Best of November 2023

The following are a dozen questions answered by the NFSA's Codes, Standards, and Public Fire Protection staff as part of the Expert of the Day (EOD) member assistance program during the month of November 2023. This information is being brought forward as the "Best of November 2023." If you have a question for the NFSA EOD submit your question online through the "My EOD" portal.

Question #1 – Sprinklers Required Above an Almost Full Height AHU Unit

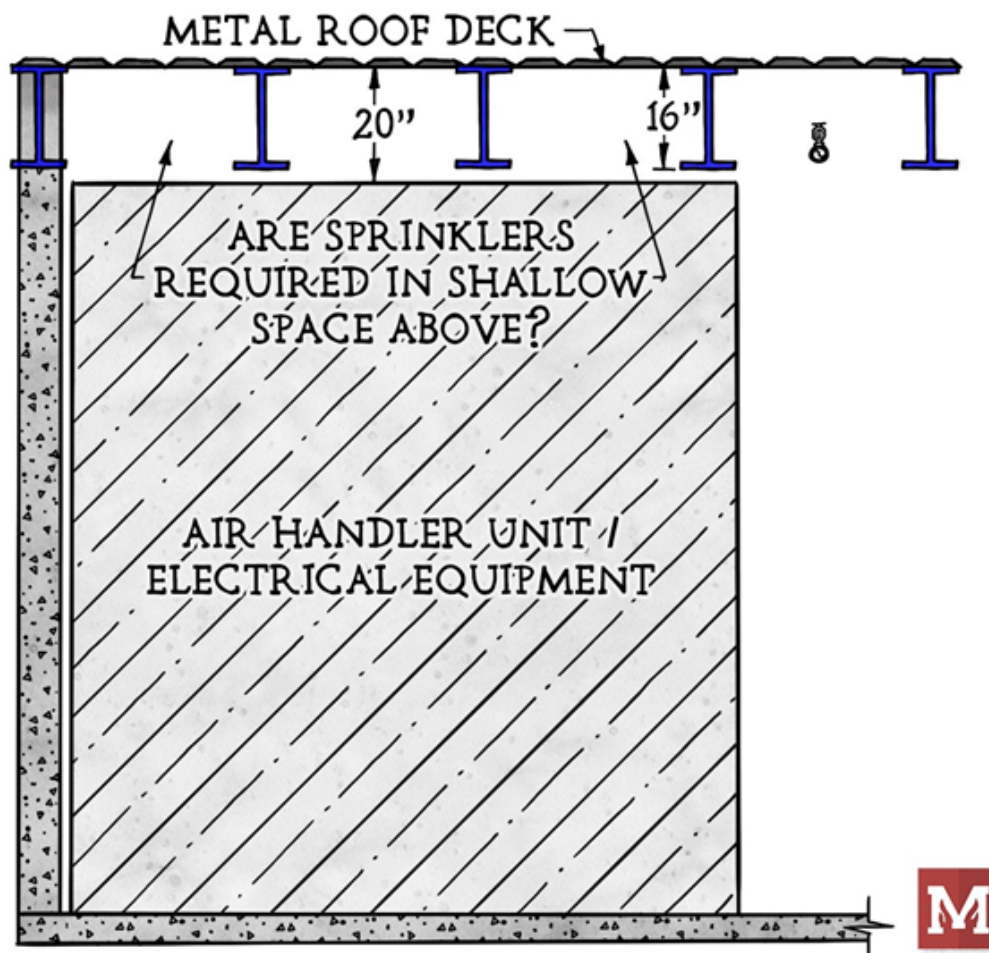
There is a large and tall air handling unit (AHU) unit that sits with its top 4 inches down from the I-beam. The I-beams are 16 inches deep. There is not a way to install fire sprinkler piping in this area unless somebody literally crawls in that 20-inch gap between the I-beams.

Can fire sprinklers be omitted above the AHU unit?

The purpose of NFPA 13 is spelled out in Section 1.2.1 which states: "The purpose of this standard shall be to provide a reasonable degree of protection for life and property from fire through standardization of design, installation, and testing requirements for sprinkler systems, including private fire service mains, based on sound engineering principles, test data, and field experience." The phrase "to provide a reasonable degree of protection" should be emphasized here. NFPA 13 cannot contemplate protection for all possible building arrangements and component installations.

Most of the model building and fire codes have language dealing with practical difficulties; here is what the International Fire Code says on this topic: "104.8 Modifications. Where there are practical difficulties involved in carrying out the provisions of this code, the fire code official shall have the authority to grant modifications for individual cases, provided that the fire code official shall first find that special individual reason makes the strict letter of this code impractical and the modification is in compliance with the intent and purpose of this code and that such modification does not lessen health, life and fire safety requirements."

Installing sprinkler piping above the AHU in question appears to be a practical difficulty. Here are some possible options, although there certainly could be others:

1. Request an exemption from providing sprinkler protection based on reasonableness and practical difficulties using the language above. Perhaps a compelling argument is that the AHU is non-combustible and poses no discernable fuel load.
2. Request an alternate means of compliance; perhaps move the branch line beyond the perimeter of the AHU and provide sidewall or extended coverage sprinklers to spray into the area.
3. Enclose the area above the AHU with non-combustible construction (such as gypsum or metal) to create a non-combustible concealed space where sprinklers are not required per NFPA 13 (2022 edition) – Section 9.2.1.2.

Question #6 – HVLS Fan

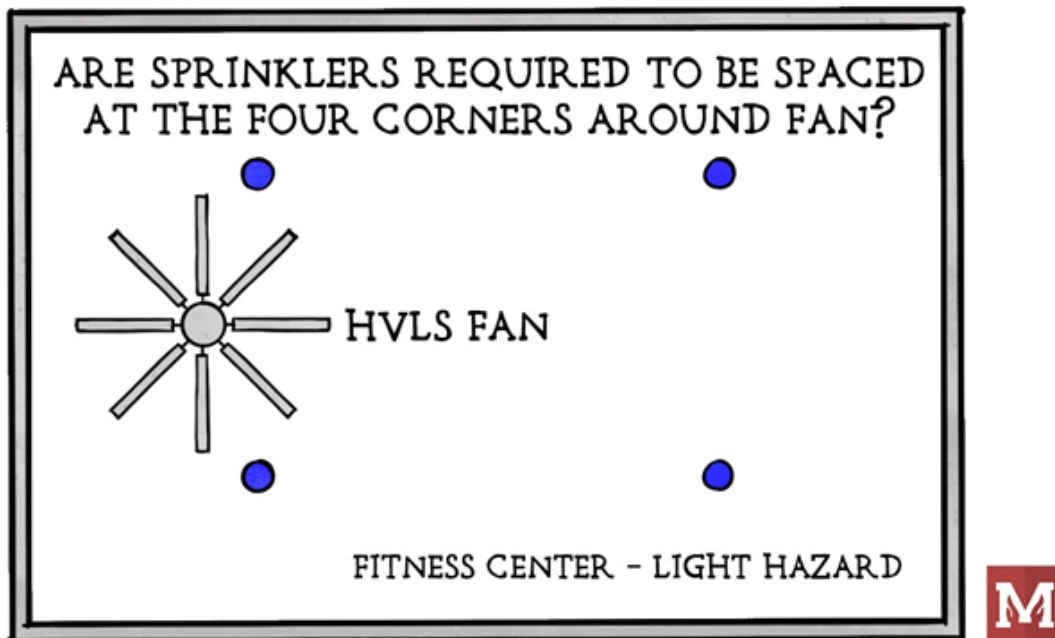
A clubhouse building has an 8 foot diameter high volume low speed (HVLS) fan in a fitness room.

Do the standard spray quick response sprinklers really need to be spaced at the four corners around the fan even though the sprinklers, as shown, are far enough away to not be obstructed by the fan?

Yes, if the fan in question is considered a HVLS fan, NFPA 13 requires that the fan be centered (approximately) between four sprinklers.

Section 11.1.7 for design approach and high-volume low speed fans indicates the installation of HVLS fans in buildings equipped with sprinklers, including ESFR sprinklers, shall have the HVLS fan centered approximately between four adjacent sprinklers. The standard does not provide an exception to this requirement.

In this case, assuming the fan meets the definition of a high-volume low speed fan provided in Section 3.3.14, Section 11.1.7 would be applicable to center the fan approximately between the four adjacent sprinklers. It may be possible to determine the fan speed does not meet the definition.

The Annex Section A.11.1.7 references the test data reports. It may be possible to review these reports and provide an equivalent design as permitted by Section 1.5. It appears the intent of the standard is to center the fan to provide the minimum effect on both sprinkler activation time as well as obstruction to sprinkler pattern development.

Question #12 – Fabric Ducts

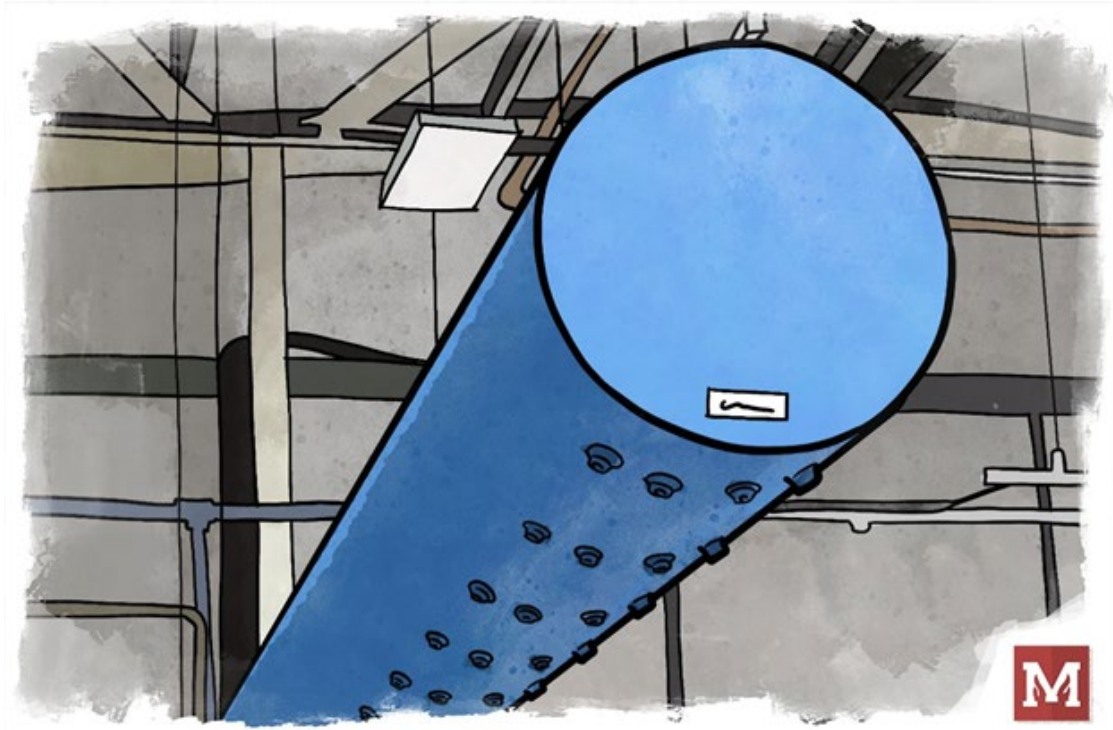
A project includes "fabric ducts" that are in excess of 4 feet when inflated.

Do these fabric ducts qualify as a continuous obstruction as it is not "permanent" in nature and can be deflated when not in use.

The duct described requires sprinklers below per NFPA 13 (2022 edition) Section 10.2.7.4.2 which requires sprinklers to be installed under fixed obstructions over 4 feet wide.

Section 9.5.5.3.2 does state that sprinklers are not required below obstructions that are "not fixed in place." However, this section is intended for objects such as tables and other movable furniture. The duct is a part of a fixed building system therefore it is not movable and would still create an obstruction when inflated and should be treated as an obstruction.

This topic was informally discussed by the installation committee recently and the consensus was that these fabric ducts should be treated as obstructions (when over 4 feet in width when inflated.) It was also noted that many of these fabric ducts include a rigid frame and would not collapse when not in use.
